Item Name: Cable Assembly (212/214/412)

# DART SERVICE INSTRUCTION

TO AMEND IIN-D412-704 REV. C OR EARLIER  
AND ICA-D412-704 REV. 4 OR EARLIER  
REF CANADIAN STC SH93-34  
REF FAA STC SR00957NY  
REF EASA STC EASA.IM.R.00696

## PURPOSE

Figure 5 - Detail L or Figure 25-4 - Detail L

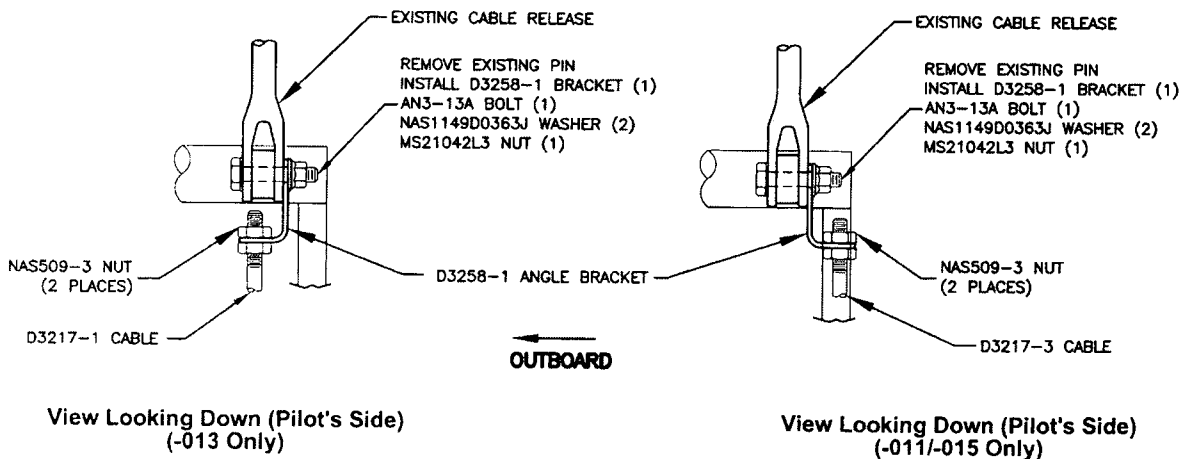
The purpose of this Dart Service Instruction is to correct part number error in Installations Instruction IIN-D412-704 Rev. C or earlier and Instructions for Continued Airworthiness ICA-D412-704 Rev. 4 or earlier. The AN3-13A bolt should be replaced with an AN3-10A bolt in Figure 5 - Detail L in IIN-D412-704 and Figure 25-4 Detail L in ICA-D412-704. See sheet 2.

Revise Detail L Figure 5 of IIN-D412-704 and Detail L Figure 25-4 of ICA-D412-704 as follows:

Qty -043	Qty -045	Part Number	Description
X		D205-704-043	CABLE ASSEMBLY (205)
	X	D412-704-045	CABLE ASSEMBLY (210/212/214/412)
1	1	AN3-10A	BOLT
